# MPRS Enhancement for Improved Error Handling

Glen Kramer, Broadcom Ltd.

Adopt the State Diagrams and Definitions for transmission envelopes shown in kramer\_3ca\_1\_0917 slides 10-21.

# Error Handling Improvements

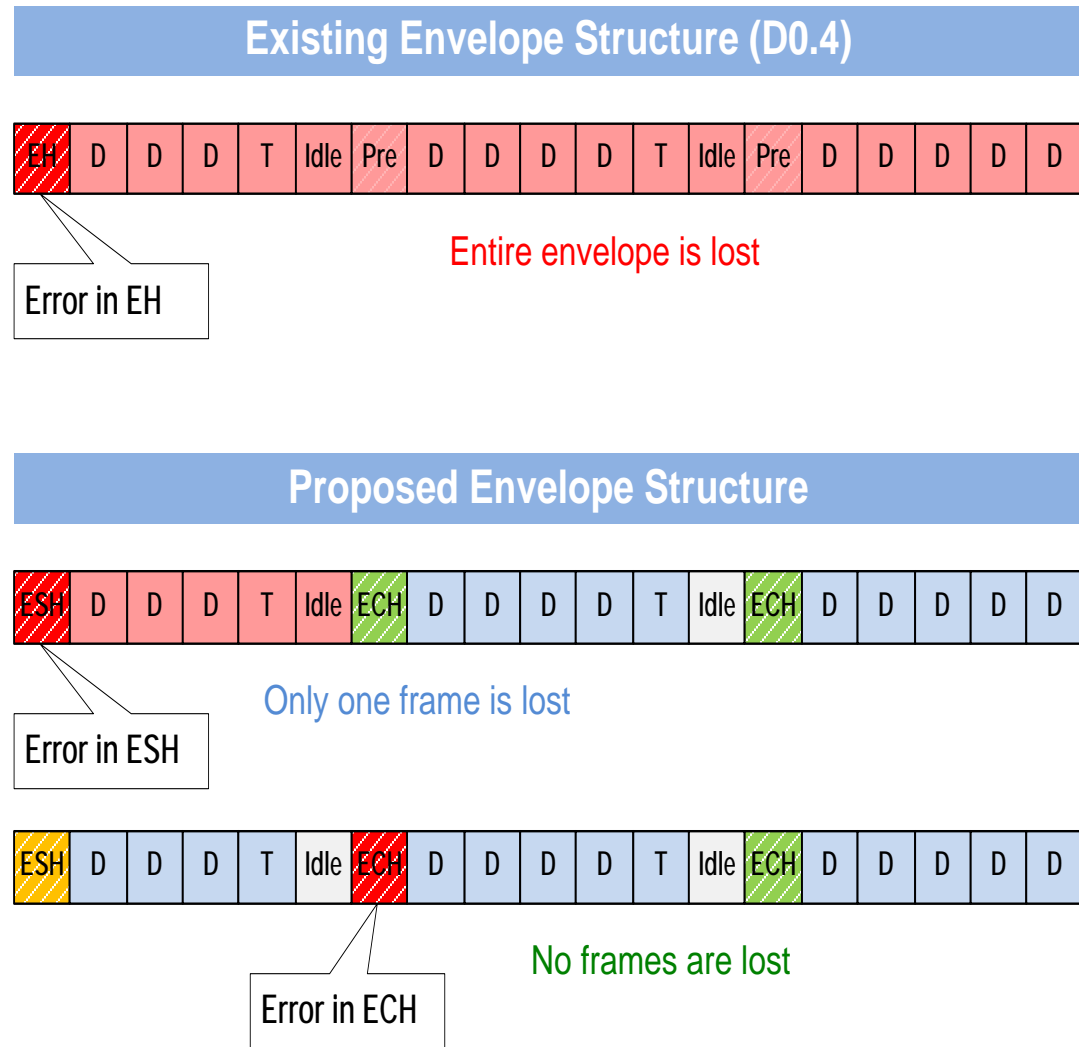
- ❑ In current version, an error in envelope header results in loss of entire envelope
- ❑ In new proposal, the ECH is an additional opportunity for error recovery
  - Loss of ESH results in loss of at most one frame
  - Loss of ECH results in no data loss (previous envelope header info remains valid)

## Existing Envelope Structure (D0.4)

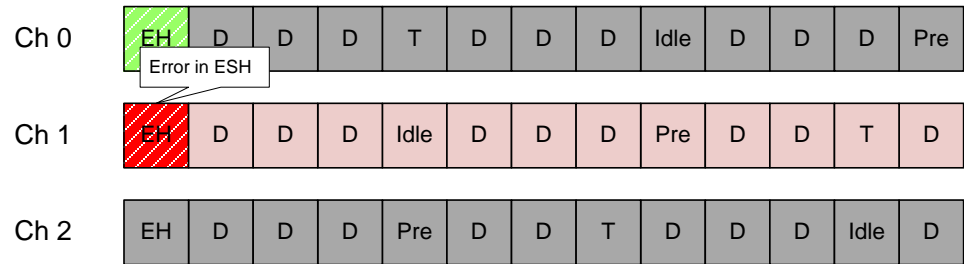
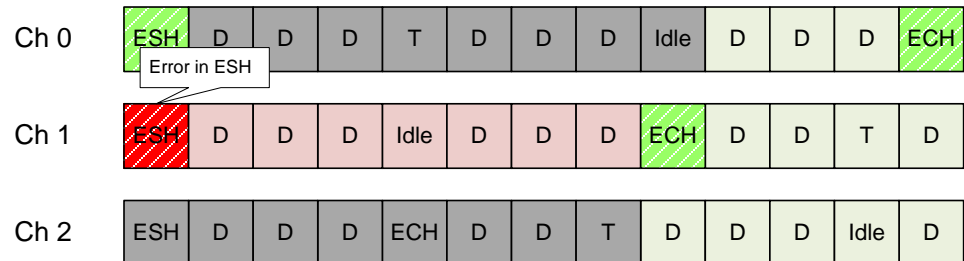
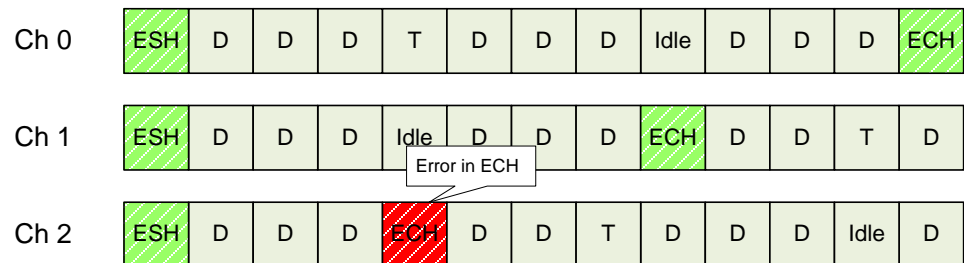
- ❑ In current version, an error in envelope header results in loss of multiple envelopes
- ❑ In new proposal, multiple frames may be lost, if the error happen in the ESH on one of the channels. But the data will recover when the next ECH is encountered on the affected channel.

Entire Envelope is Lost

Only two frames are lost

No frames are lost

# Envelope Header Format

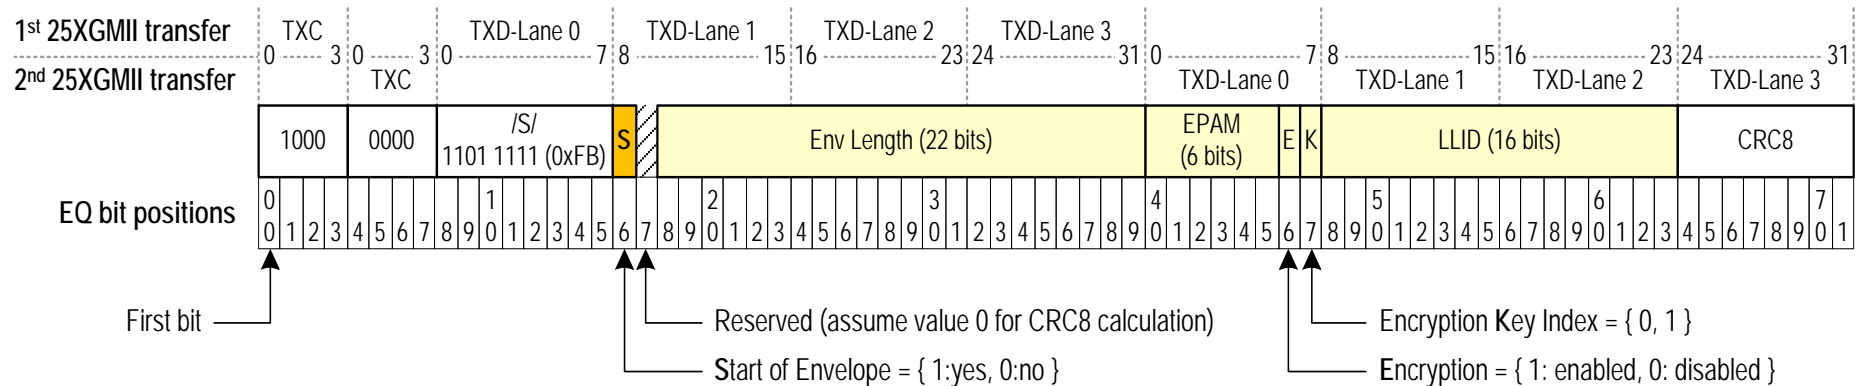
- ❑ Both ESH and ECH have identical formats
- ❑ The only difference is the value of the **Start** flag (replaces Preamble flag)
  - In ESH, Start = 1 (true)
  - In ECH, Start = 0 (false)

Figure 143-1—ONU MPRS Input Process state diagram

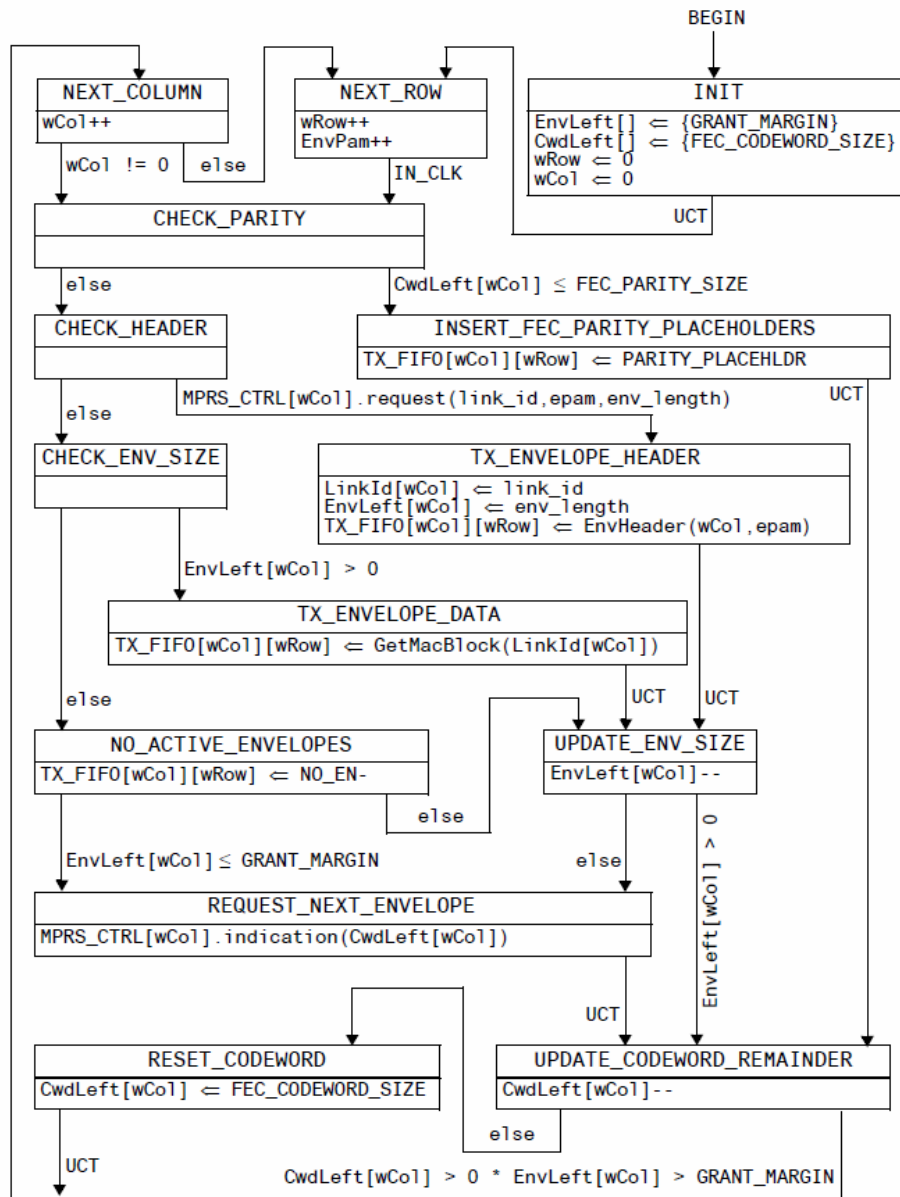
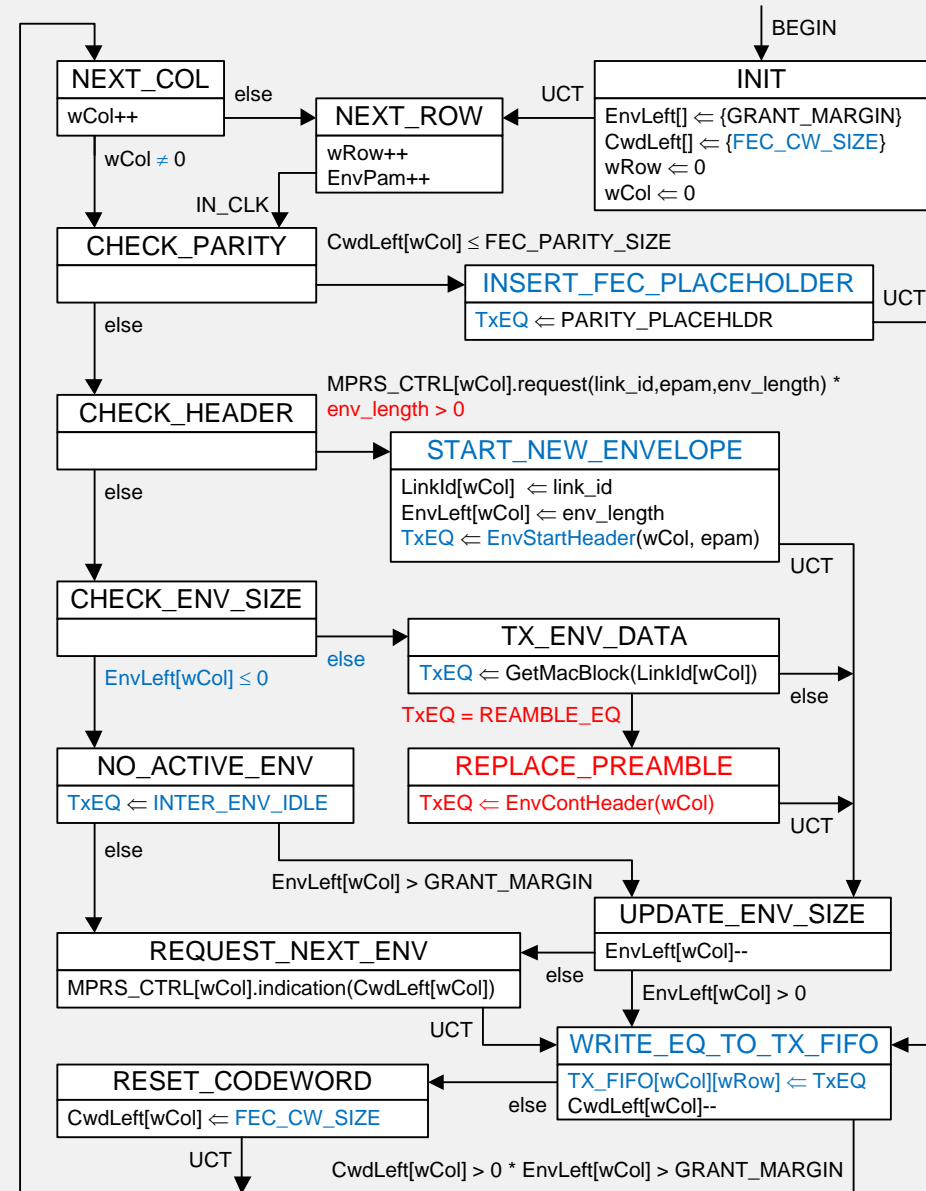
# MPRS Input Process

- Function **GetEnvHeader(...)** is replaced by two functions:
  - EnvStartHeader(...)** returns the value of ESH
  - EnvContHeader(...)** returns the value of ECH

- A new state **REPLACE\_PREAMBLE** is added

Figure 143-4—OLT MPRS Output Process state diagram

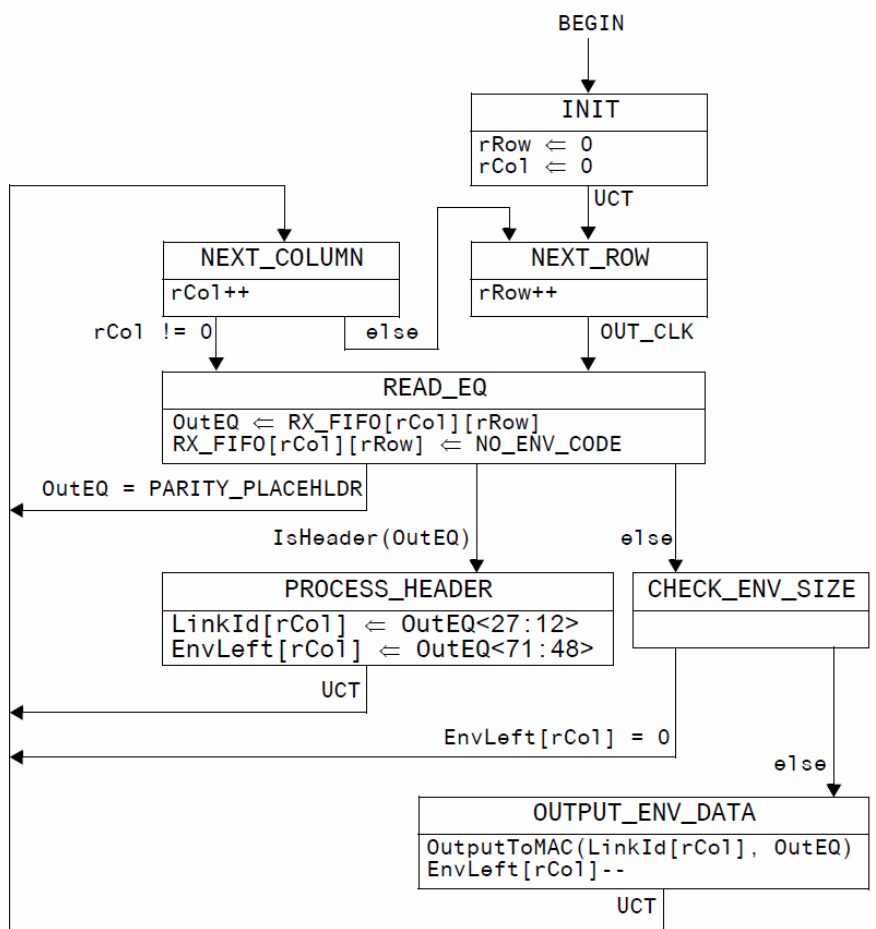
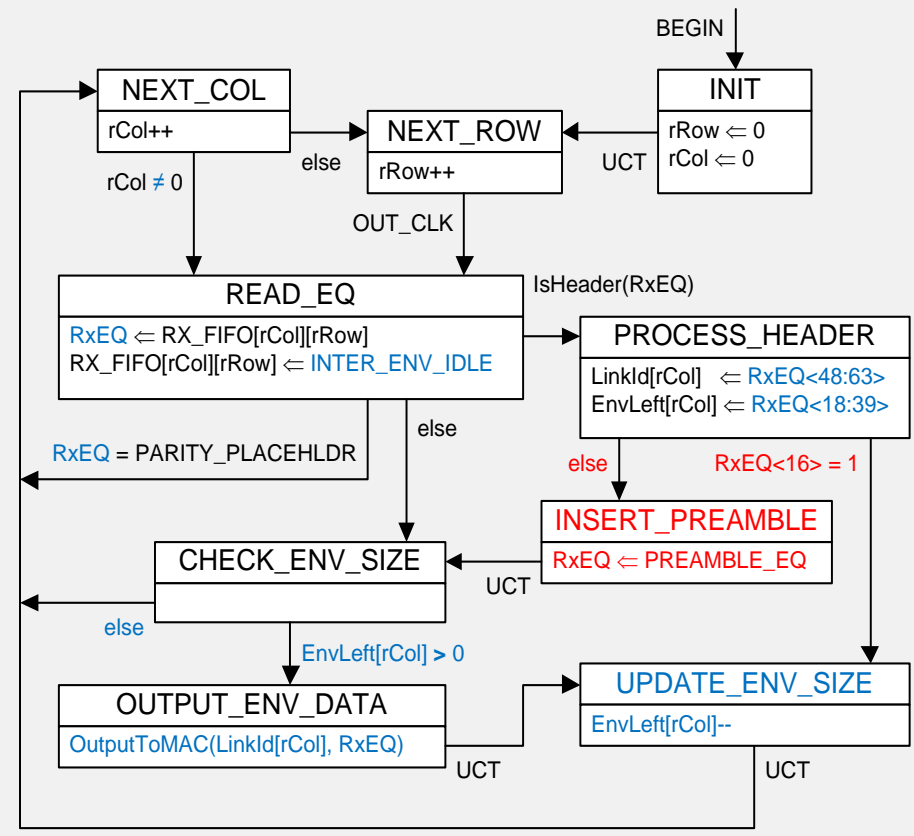
# MPRS Output Process

- Added state  
INSERT\_PREAMBLE
  - Replaces ECH with a regular preamble before passing RxEQ to MAC
